SOUTHERN REGIONAL LOAD DESPATCH CENTRE, 29, RACECOURSE CROSS ROAD, BENGALURU - 560 009

सन्दर्भ/Ref: एसआरएलडिसी SRLDC/SO/2026/

Sub: URGENT - Under-Frequency Tripping of GREENKO PSP Units in Generation Mode on 25-07-2026 and Compliance of under frequency settings with CEA Connectivity Standards

Frequency at Somanahalli PMU

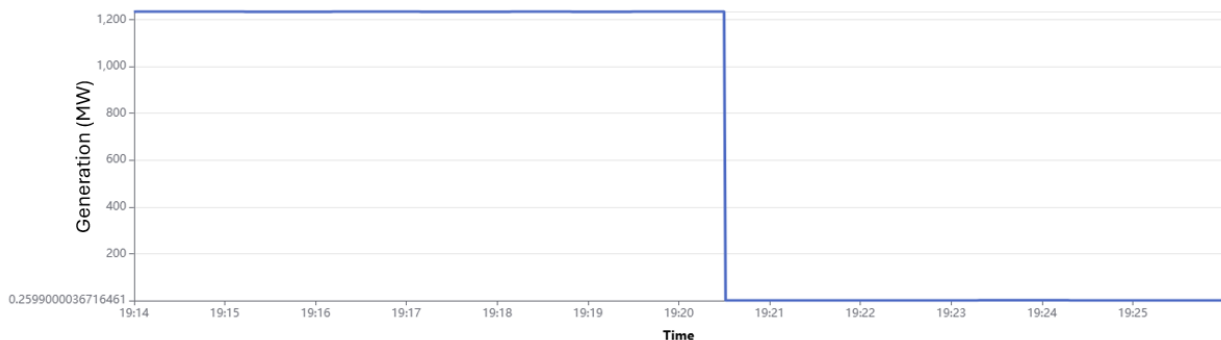
It is to bring to your kind attention that on 25-07-2026 at 19:20 Hrs, when the system frequency reached 49.5 Hz, the GREENKO Pumped Storage Plant (PSP) units operating in generation mode tripped on under-frequency protection. As informed by GREENKO, all five generating units in operation tripped simultaneously, resulting in a generation loss of approximately 1200 MW, which further deteriorated the system frequency to around 49.42 Hz as shown below.

- Review and modify the under-frequency protection settings applicable during generation mode to ensure compliance with the Central Electricity Authority (Technical Standards for Connectivity to the Grid) Regulations, with the under-frequency protection setting being lower than 47.5 Hz, in consultation with OEM.
- Submit a compliance report, along with the revised protection settings at the earliest
